**Re: Old Dominion Freight Line,  
330 Airport Rd NW  
Request for Permanent C.O. –Accepted  
Engineer's Stamp dated: 3-27-13, (K10D008A)  
Certification dated: 11-05-13**

**File: K10D008A**

RE: **Old Dominion Freight Line - 330 Airport Road NW**  
**Grading & Drainage Plan and Drainage Report**

**RE: OLD DOMINION FREIGHT LINE, 330 AIRPORT ROAD NW  
RESPONSES FOR GRADING & DRAINAGE PLAN / DRAINAGE REPORT**

## Vicinity Map

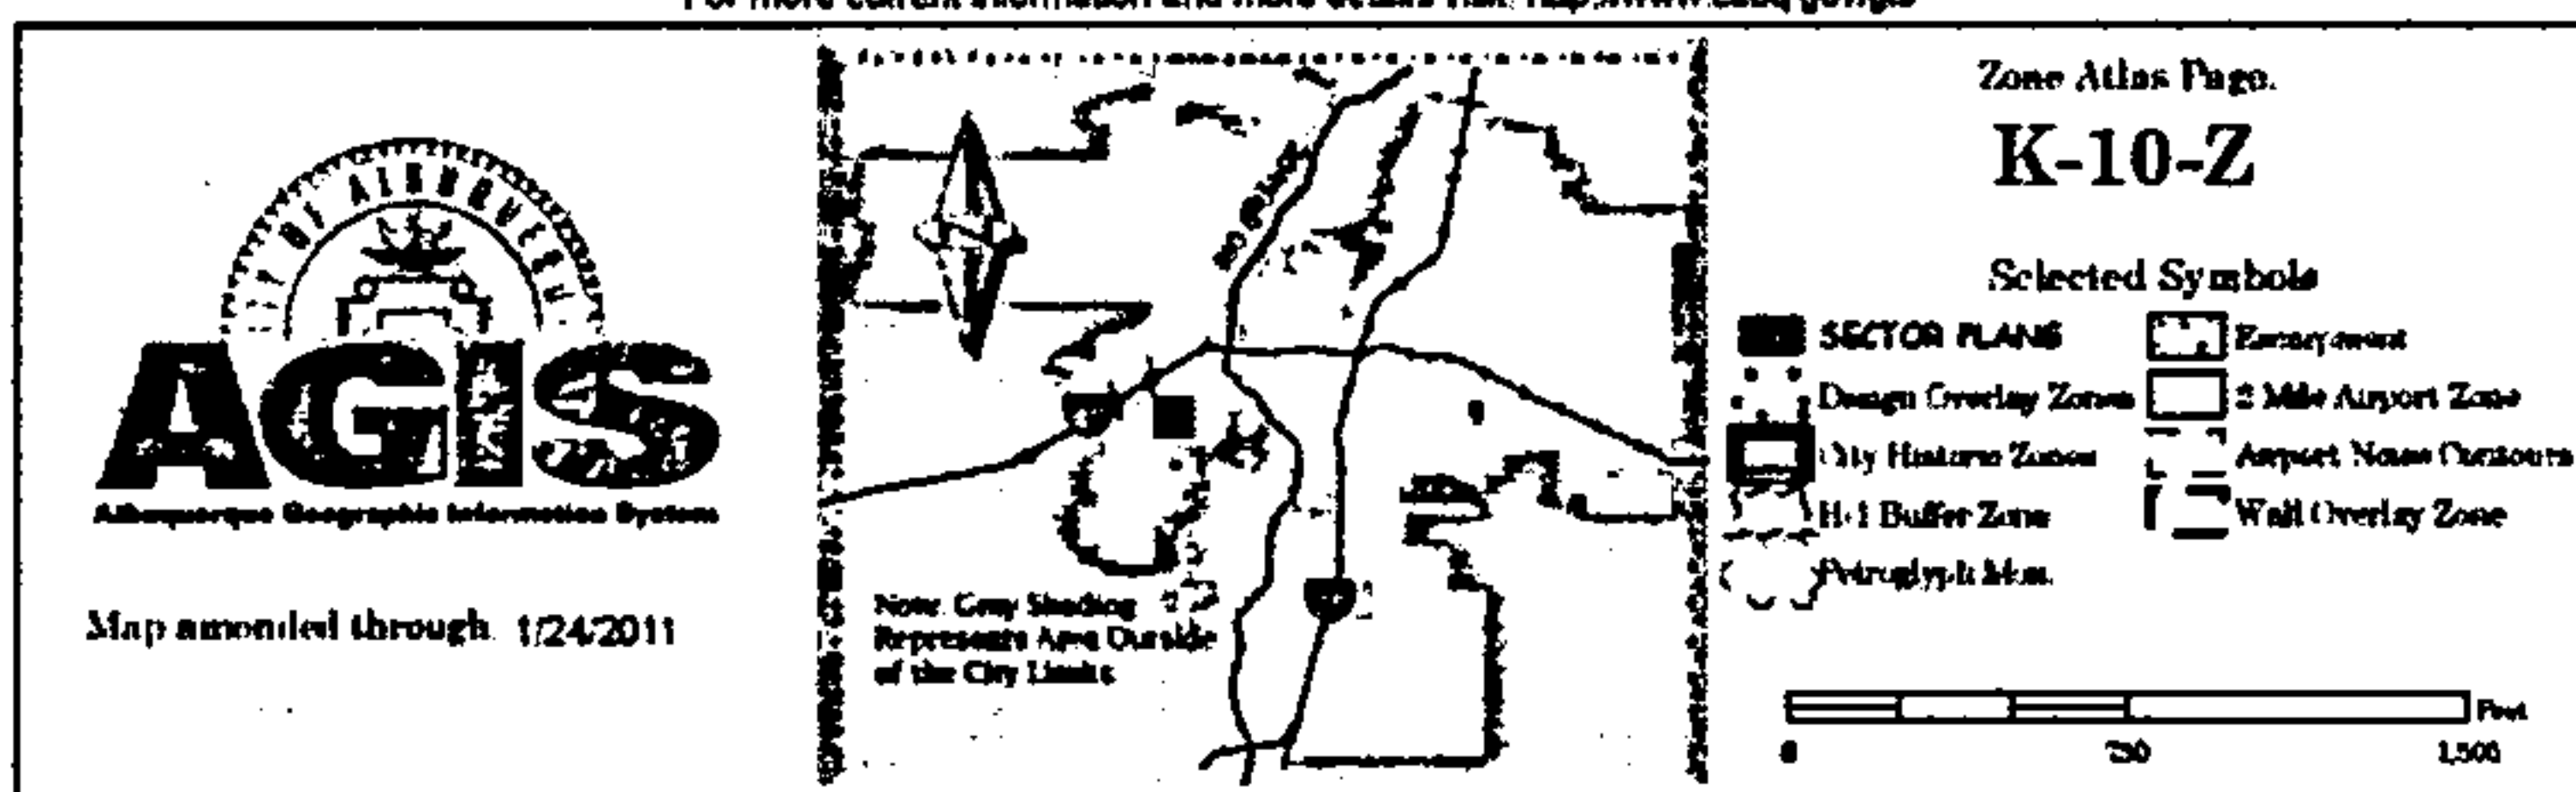
1. The report confuses Tracts B-1-A and B-1-B, and actually shows B-1-A as part of the site in the vicinity map. Please clarify.

*B-1-B is old Dominion*

*Tr. B-1-A, Not in Site*

**RESPONSE:** The north line of the vicinity map in the report was corrected to reflect Tract B-1-B. ✓
